Access Compliance Report

Public Rights-of-Way

(Curb Ramps)

Intersection ID: N/A	Main Street: MONROE_RD	Cross Street: FANNIE_CR	Location: SE
ADA ID: 522A823BE170	Ramp Type: PerpDiag	Initial Pass/Fail: Fail	Overall Compliance: No
Severity Score: 22.5			
Codes/Mitigation Info/Possible Solution		Field Measurements/Component Compliance

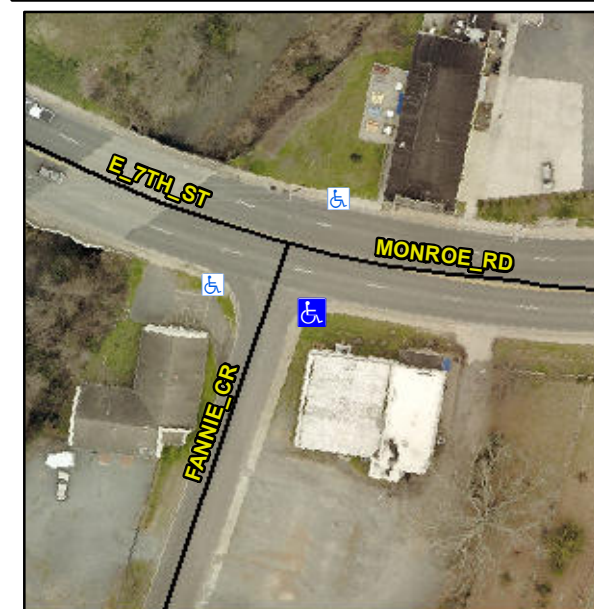
Not Found, R304.5.1, R304.2.2, R304.5.3

Compliance	Description	Data	Compliance	Description	Data
N/A	Ramp Length (in)	45.0	No	Ramp Slope (%)	10.7
No	Ramp Width (in)	37.0	No	Ramp XSlope (%)	2.4
N/A	Flare Type LT	N/A	N/A	Flare Type RT	N/A
N/A	Flare Slope LT (%)	N/A	N/A	Flare Slope RT (%)	N/A
N/A	Flare Traversable LT?	N/A	N/A	Flare Traversable RT?	N/A
N/A	Landing Length (in)	N/A	N/A	DWS Provided?	N/A
N/A	Landing Width (in)	N/A	N/A	DWS Contrast?	N/A
N/A	Landing Slope (%)	N/A	N/A	DWS Length (in)	N/A
N/A	Landing X Slope (%)	N/A	N/A	DWS Full Width?	N/A
N/A	Landing Curb? (Y/N)	N/A	N/A	DWS Offset (in)	N/A
N/A	Shared Landing?	N/A			
N/A	Gutter Ponding?	N/A	N/A	Gutter Slope (%)	N/A
N/A	Gutter Lip Ht (in)	N/A	N/A	Gutter X Slope (%)	N/A
N/A	Painted X Walk1?	No	N/A	Painted X Walk2?	No
	X Walk 1 Direction	To NE		X Walk 2 Direction	To NW
N/A	X Walk 1 Width (in)	N/A	N/A	X Walk 2 Width (in)	N/A
	X Walk 1 Slope (%)	1.5		X Walk 2 Slope (%)	2.7
	X Walk 1 X Slope (%)	2.2		X Walk 2 X Slope (%)	0.3

Remove & Replace Curb Ramp With Two New Directional Ramps or Equivalent.
